# Access Compliance Report

## Public Rights-of-Way

Intersection ID: 17169	Main Street: IDLEWILD_RD	Cross Street: CEDARS_EAST_CT	Location: SW
ADA ID: 4A0E2E1AEA2C	Ramp Type: Directional1	Initial Pass/Fail: Fail	Overall Compliance: No
Severity Score: 13.75			
Codes/Mitigation Info/Possible Solution		Field Measurements/Component Compliance

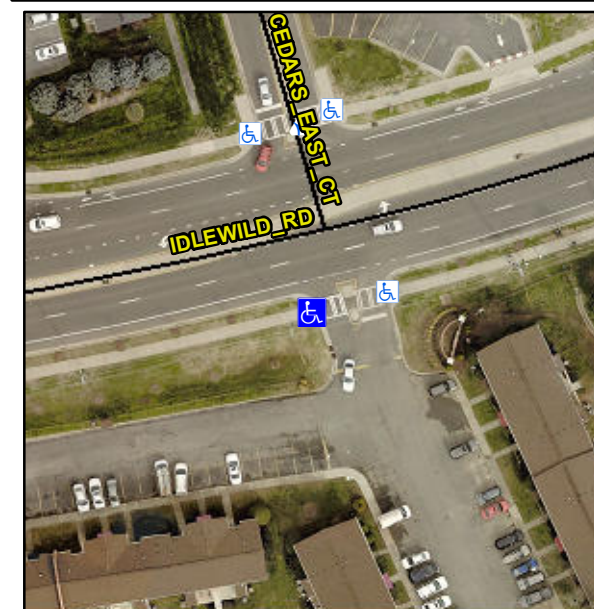
**R304.2.2, R304.5.3**

Compliance	Description	Data	Compliance	Description	Data
N/A	Ramp Length (in)	73.0	N/A	Grade Break?	N/A
Yes	Ramp Width (in)	48.0	N/A	Grade Break Slope (%)	0.0
No	Ramp Slope (%)	10.9	N/A	Grade Break XSlope (%)	0.0
No	Ramp XSlope (%)	2.1			
N/A	Flare Type LT	N/A	N/A	Flare Type RT	N/A
N/A	Flare Slope LT (%)	N/A	N/A	Flare Slope RT (%)	0.0
N/A	Flare Traversable LT?	N/A	N/A	Flare Traversable RT?	N/A
N/A	Landing Length (in)	0.0	N/A	DWS Provided?	N/A
N/A	Landing Width (in)	0.0	N/A	DWS Contrast?	N/A
N/A	Landing Slope (%)	0.0	N/A	DWS Length (in)	N/A
N/A	Landing X Slope (%)	0.0	N/A	DWS Full Width?	N/A
N/A	Landing Curb? (Y/N)	N/A	N/A	DWS Offset LT (in)	N/A
N/A	Shared Landing?	N/A	N/A	DWS Offset RT (in)	N/A
N/A	Gutter Ponding?	0.0	N/A	Gutter Slope (%)	N/A
N/A	Gutter Lip Ht (in)	0.0	N/A	Gutter X Slope (%)	N/A
N/A	Painted X Walk1?	Yes		Road Slope (%)	1.3
	X Walk 1 Direction	To E		Road X Slope (%)	1.0
	X Walk 1 Width (in)	112.0		Clear Space?	N/A

**Remove & Replace Entire Ramp.**
